Application Reference No. 251621

**Proposed Development at Land at the junction of Wellington Road and Station Road
Wokingham RG40 2AH
Impact on 4 Park Road, Wokingham,**

Proposal: Full application for the proposed erection of an apartment building comprising 21 residential units, together with associated car and cycle parking, amenity space, landscaping and refuse storage.

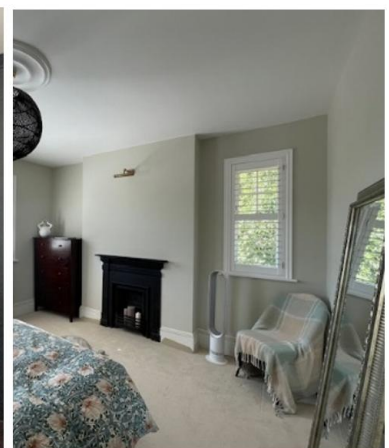
Please find below three photographs showing the windows serving the ground floor open plan living, kitchen and dining room and the first floor bedroom at 4 Park Road. The bedroom also benefits from light via the front windows, and, in respect of the living room, from the front bay windows. The proposed development will be directly in front of the side windows, reducing the light currently receivable by the rooms.

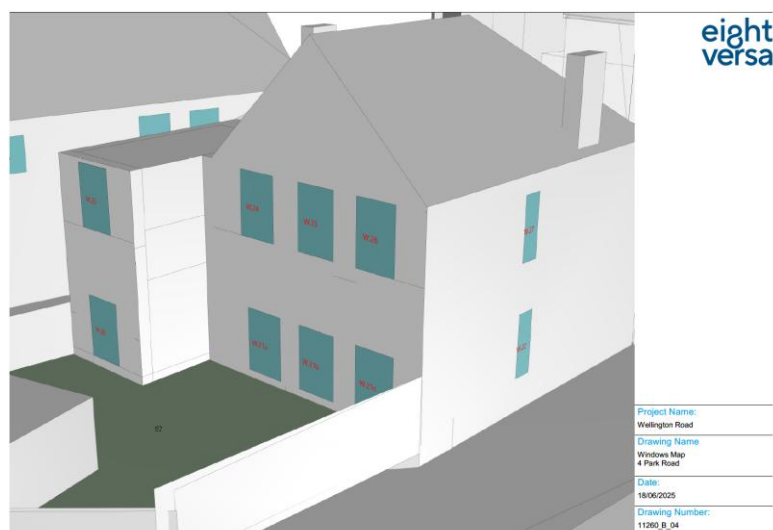
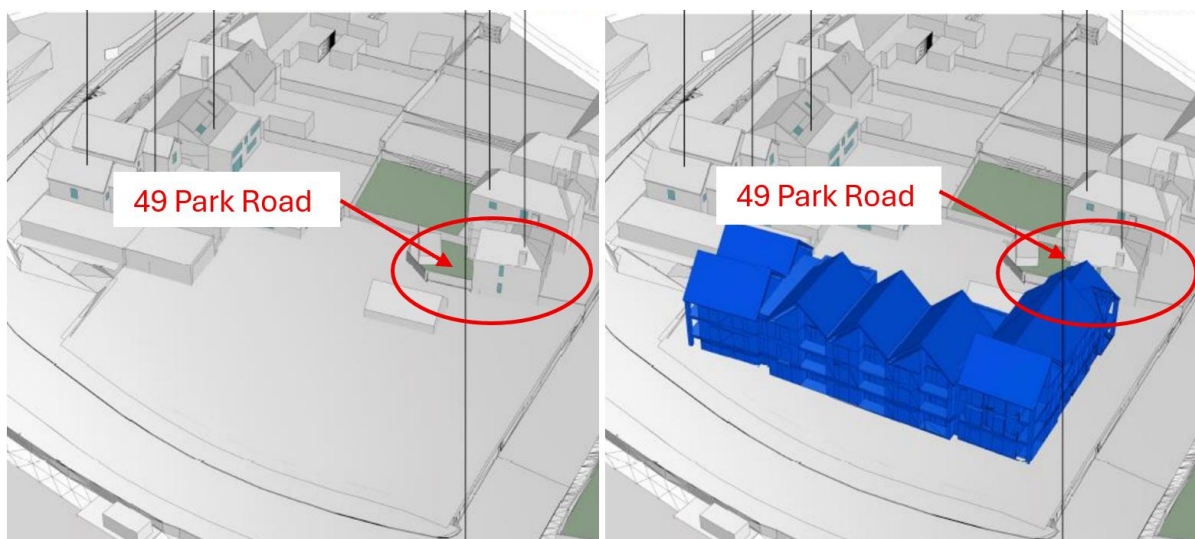
We have reviewed the daylight and sunlight study dated 20 June 2025 prepared by Eight Versa on behalf of the applicant, Wokingham Borough Council. Whilst we are unable to confirm the accuracy of the report, the results show a reduction of light to two side windows at 4 Park Road which extend beyond the BRE guidelines, although concludes that the daylight conditions to the property will remain acceptable. We do not concur with this conclusion. An increased level of overshadowing will also occur to the external garden area.

Please see below existing and proposed images of the development site, and a window key for 4 Park Road, taken from the Eight Versa daylight and sunlight report. It is evident that the side windows at 4 Park Road will be restricted of light due to the proposed development.

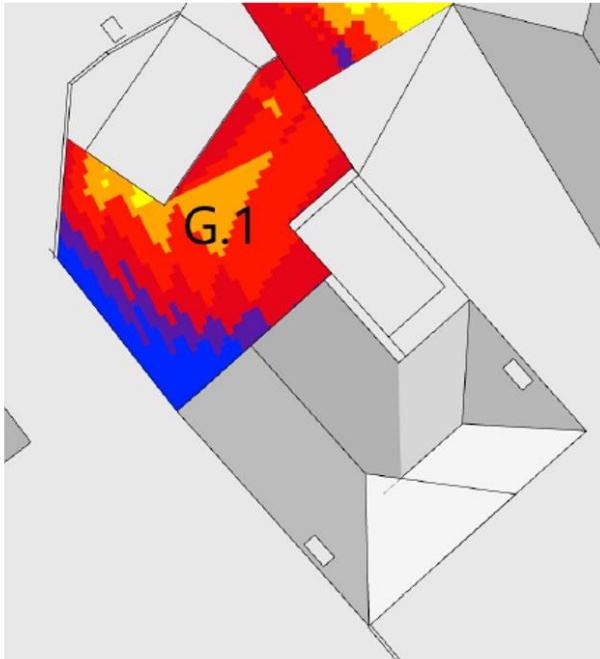
The level of Daylight Distribution to the dining room (referred to below as R.22) is reduced from 86.3% down to 43.2%, which equates to a reduction of 0.50 times its former value. This is a loss of daylight to the room of 49.9%, beyond the 20% (0.8 times the former value) recommendations of the BRE guide.

In respect of the bedroom, the Daylight Distribution to the area of the room served by the side window is reduced from 85.7% down to 54.7%, which equates to a reduction of 0.65 times its former value. A loss of 36.2% of Daylight Distribution.

The Eight Versa report concludes that adequate light from the front and rear apertures serving the rooms would result any loss of light as a result of the proposed development unlikely to be perceptible by our clients. We do not concur with this conclusion due to the distances between the front windows and the rear French doors, to the side window serving an area to the centre of the room.

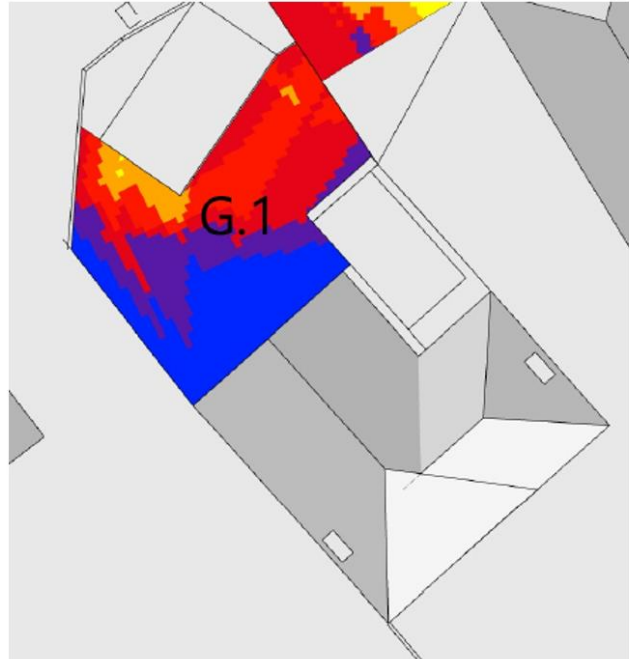
The Eight Versa results below show that the garden (G.1) currently enjoys two hours of sunlight to 69.9% of its area, which will be reduced to 51.8% once the proposed development is built. The reduction amounts to a 25.9% area of garden which can receive two hours of sunlight and only marginally avoids a fail of the BRE test.

The proposed results for the garden do not identify the development in situ on the 3D drawing, with only the existing condition visible. The proposed development should be identified on the 3D drawing to confirm the extent of development tested.
